SUBJECT: SAFETY RECALL OF SE-GI WINDOWS

Ref.: **NHTSA # 10V-373**
TRANSPORT CANADA #TC 2010-270
MCI Service Bulletin 348

Service Bulletin No. 348

MODEL E4500 / J4500 Series Coaches	TYPE Field Change Program	SECTION/GROUP 3-Body	DATE Aug. 16, 2010
SUBJECT SE-GI WINDOW GLASS ASSEMBLY ADHESIVE DEBONDING			
CONDITIONS

Figure 1.

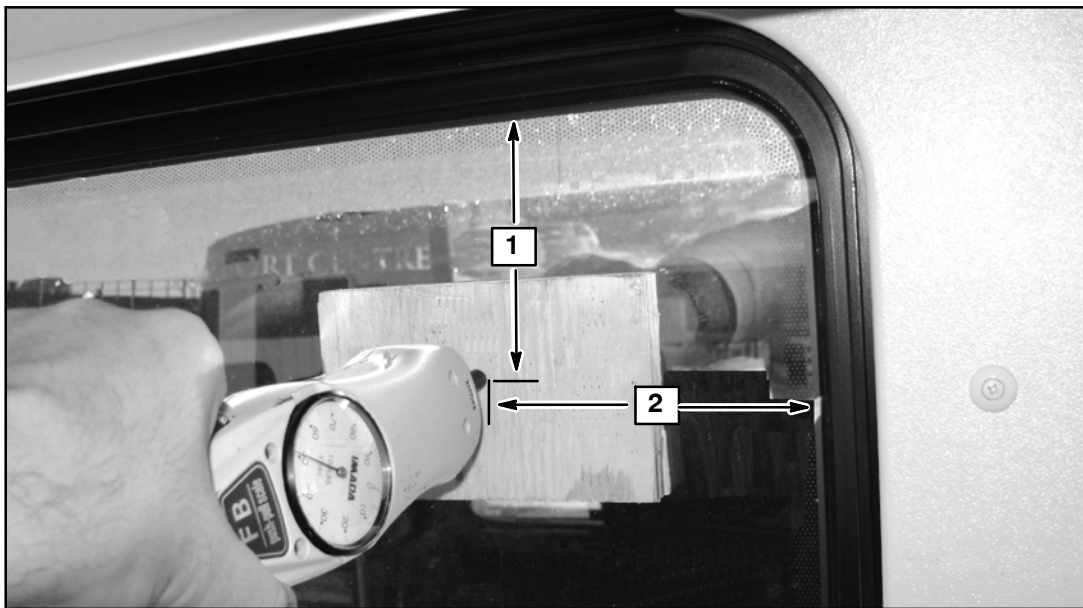
3. Ensure window is in locked position.
4. From inside the coach, carefully position a 4.0 x 4.0 x 0.5 inch flat wood block flat against the glass surface, the center of which should be six (6) inches from both edges (as shown in Figure 1). Position a push / pull gauge at the center of the wood block and apply 50 lbs. push force against the glass, perpendicular to the glass surface, to accentuate any partial de–bonding that may exist.
5. Look for any evidence of de-bonding from the frame, as force is applied.

Figure 3.

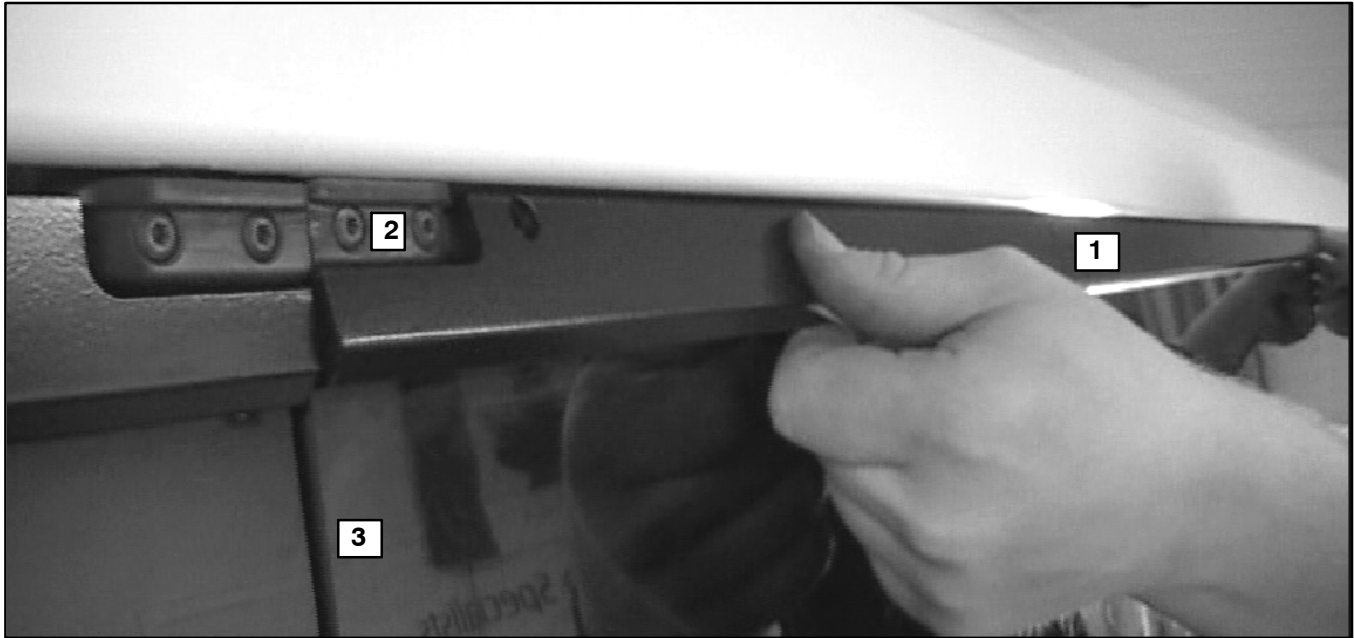
21. Align the hinge clip with the window (fore and aft) and swing the clip down until the double-sided tape contacts the glass (refer to Figure 3).
